STAFF REPORT  
(One-Step Final Plat)

**CASE NUMBER:** SUB 2007-43 -- KANSAS STATE BANK ADDITION

**LOCATION:** North of Kellogg, on the east side of Maize

**Kansas State Bank- Maize Rd. at Kellogg**  
 Proposed Drainage Solution

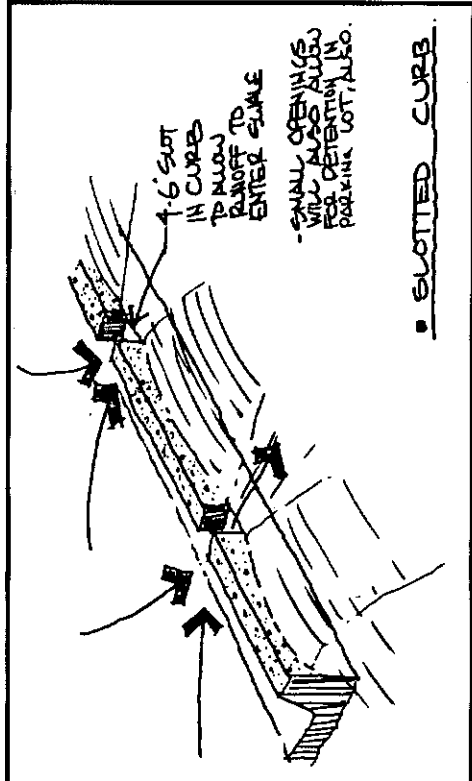
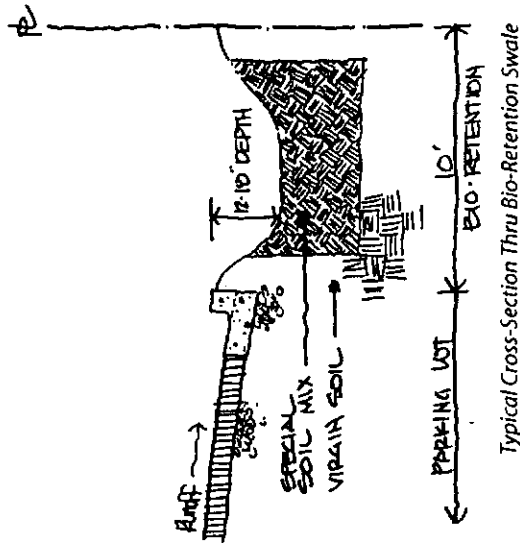
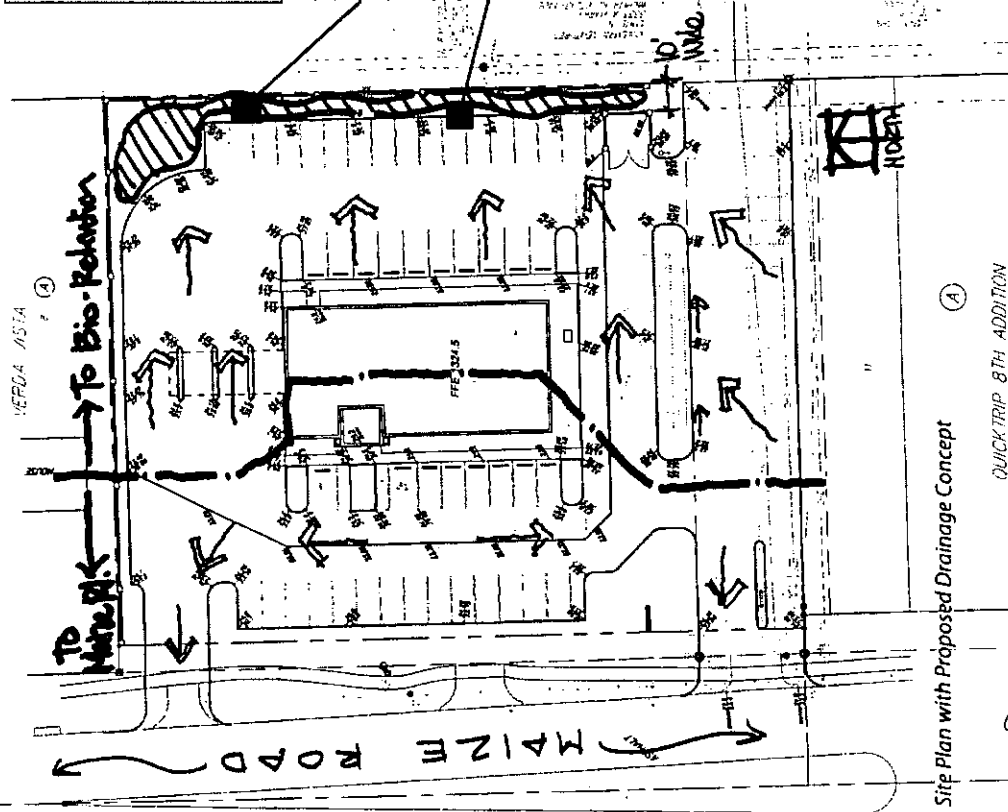
- C. **City Engineering** needs to comment on the status of the applicant's drainage plan.
- D. Access controls have been platted in accordance with the site plan submitted for Conditional Use approval. The plat proposes two access openings along Maize Road.
